Site Development Plan Parkview at Emerson Age Restricted Adult Housing-MIHU's

Section 3, Area 4, Parcel A-I 6th Election District Howard County, Maryland

reoline revision to upoate appress chart
10/27/08	\bigcirc	REDLINE REVISION TO REALIGN SWM FACILITY PER F-09-34
DATE	N/S	REVIGION

SDP-06-159

> > General Notes

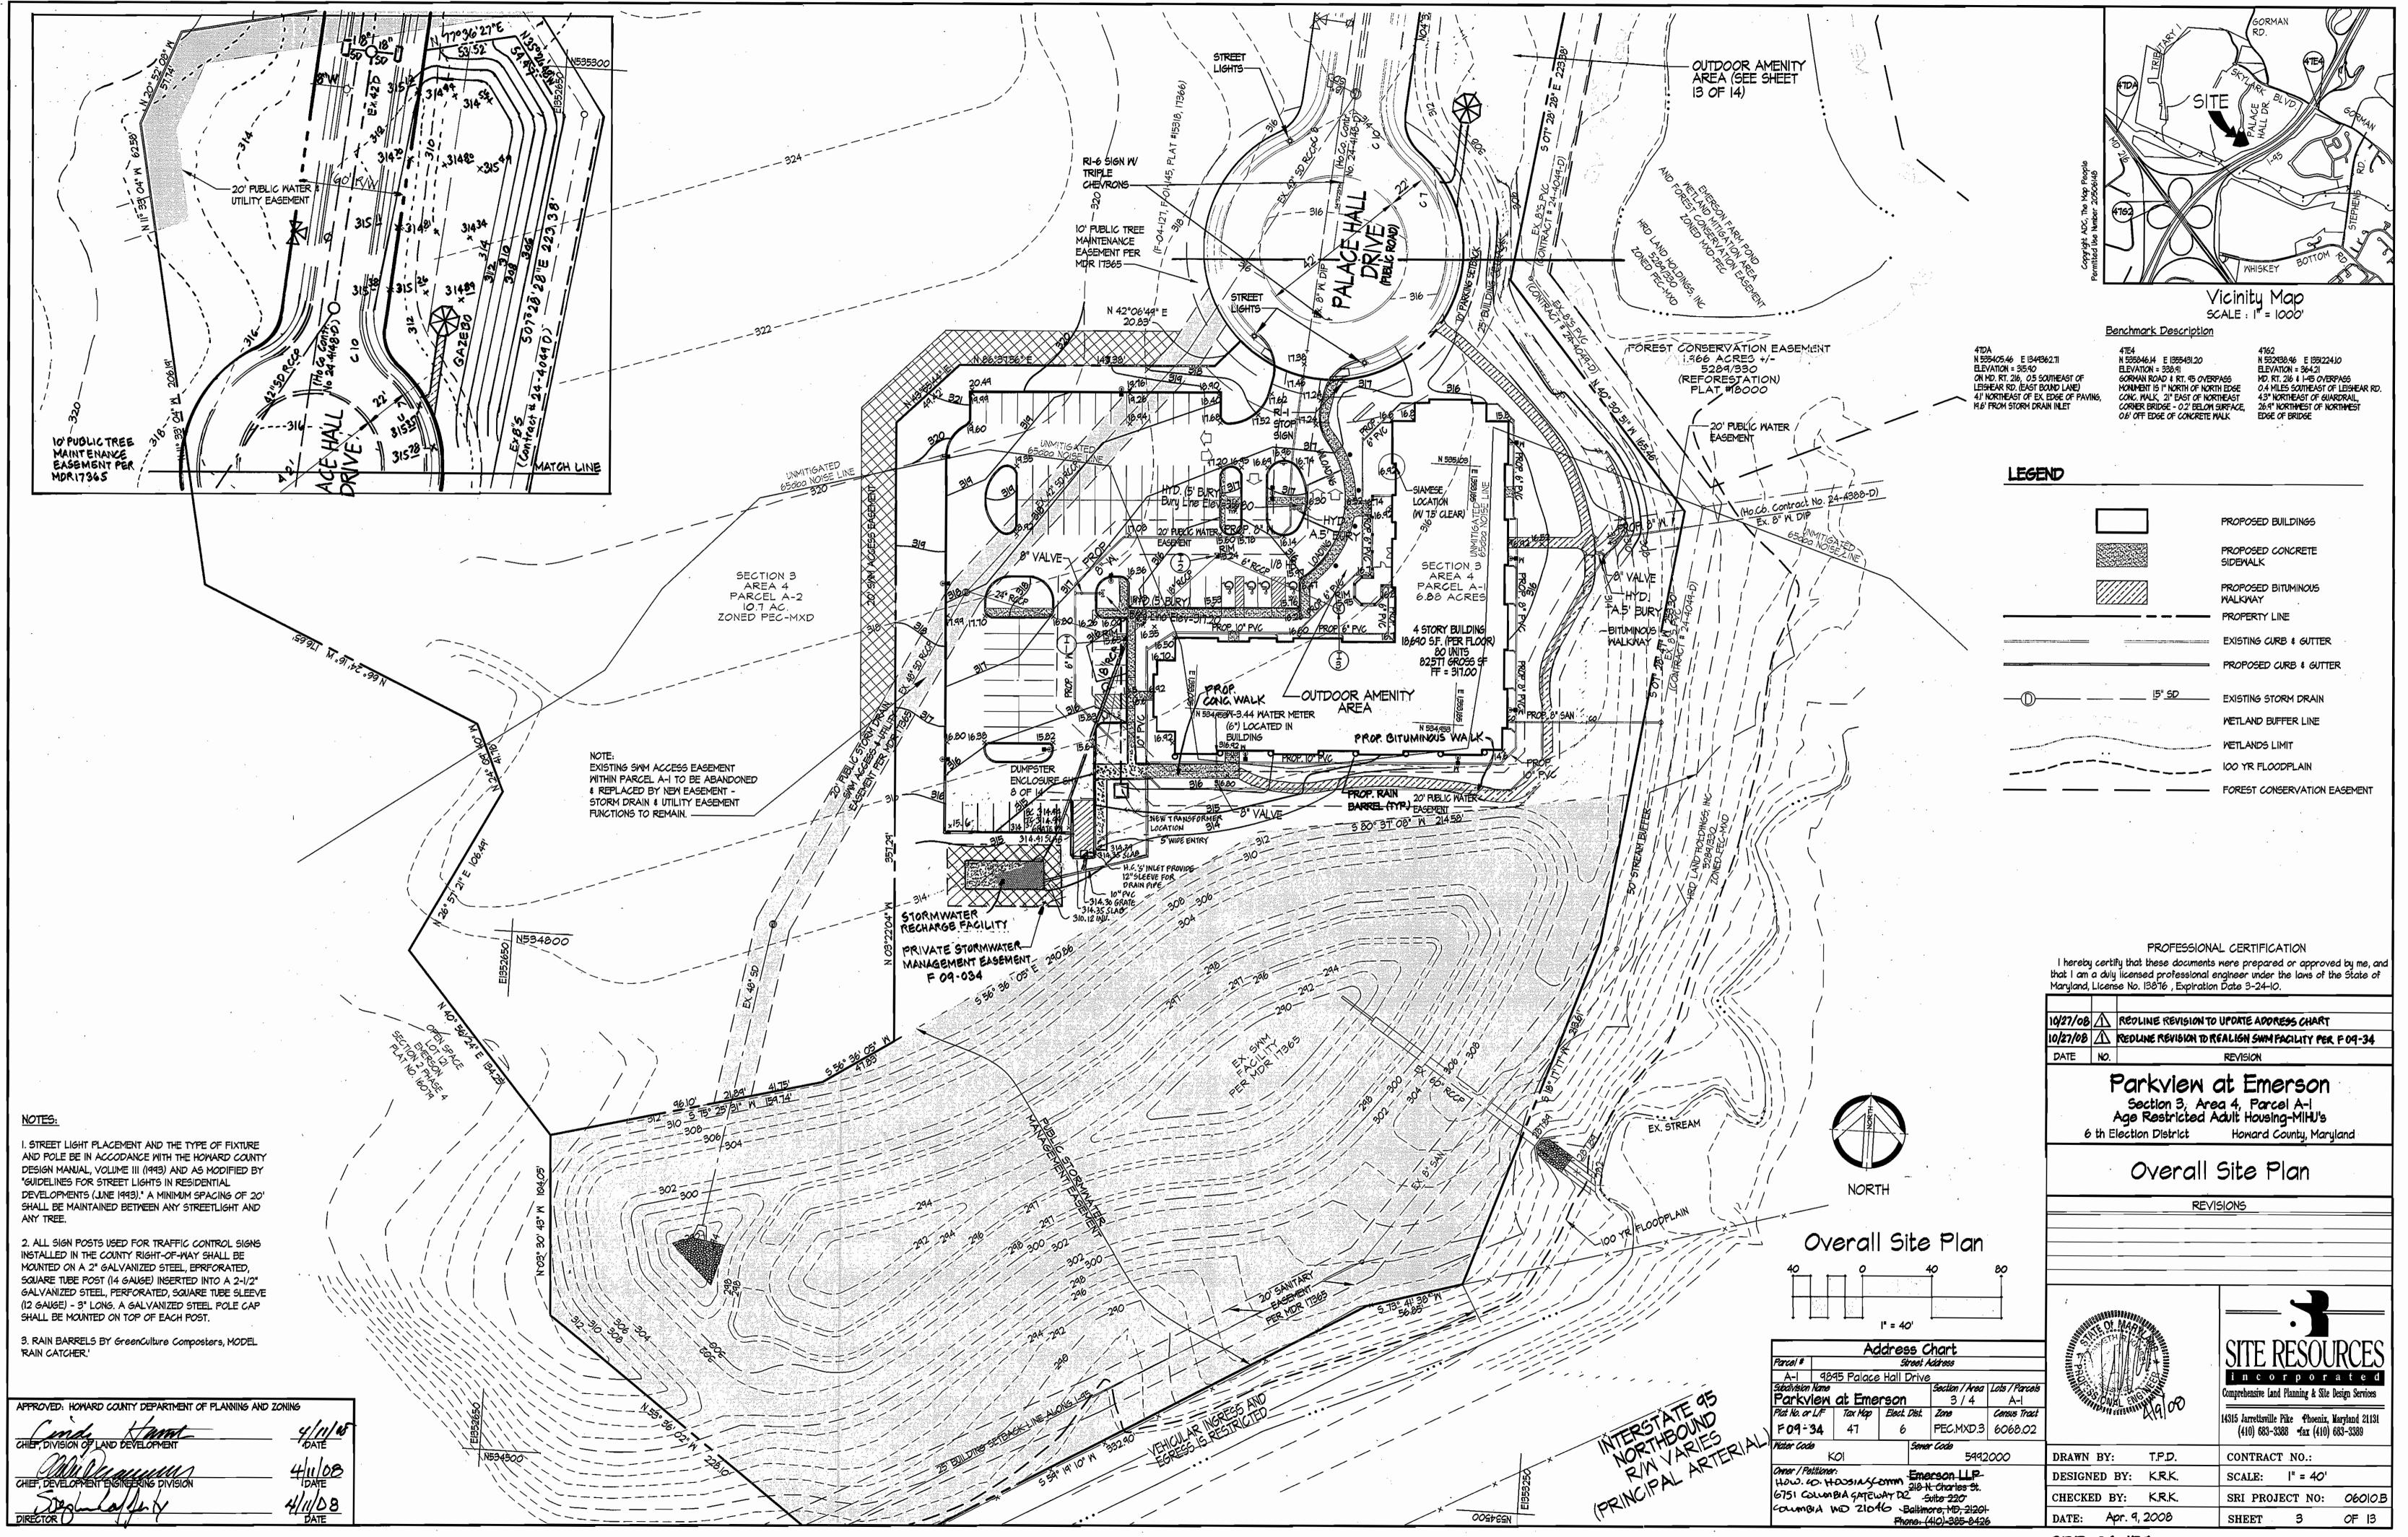
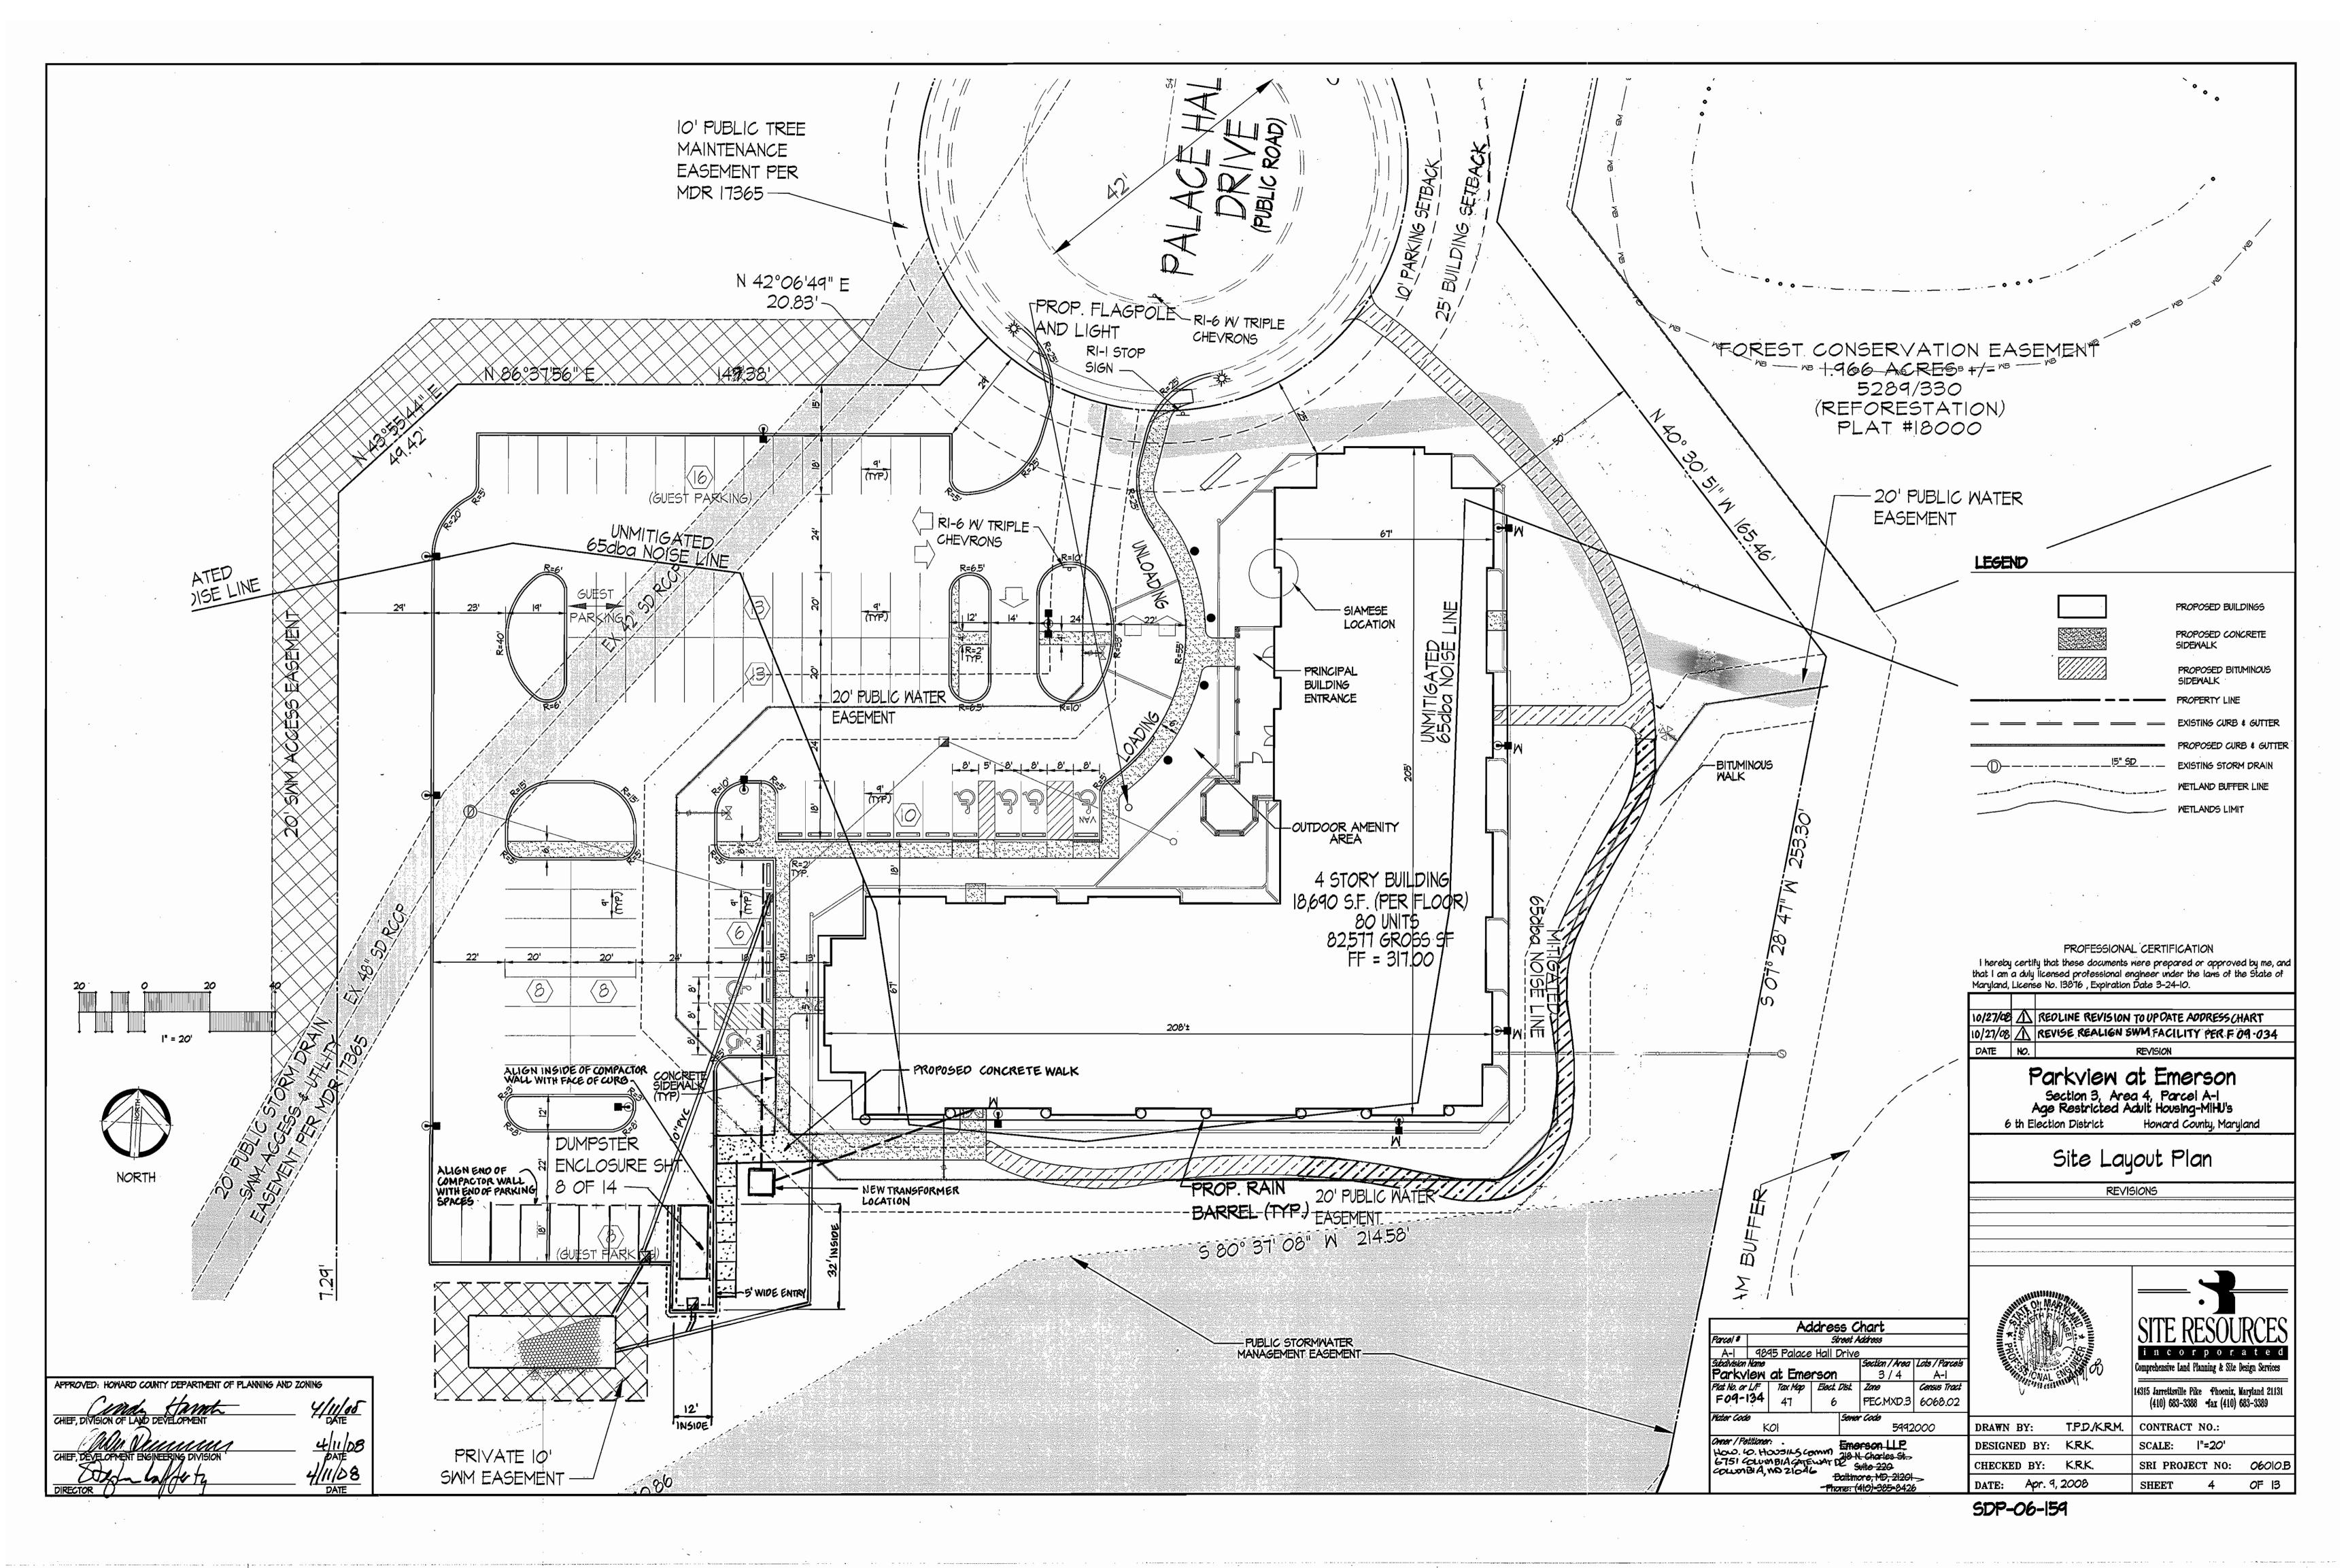
10/27/08 A REDLINE REVISION TO UPDATE ADDRESS CHART REVISE GENERAL NOTE \$24 PER FOO -34 PLAT OF REVISION DATE NO. REVISION
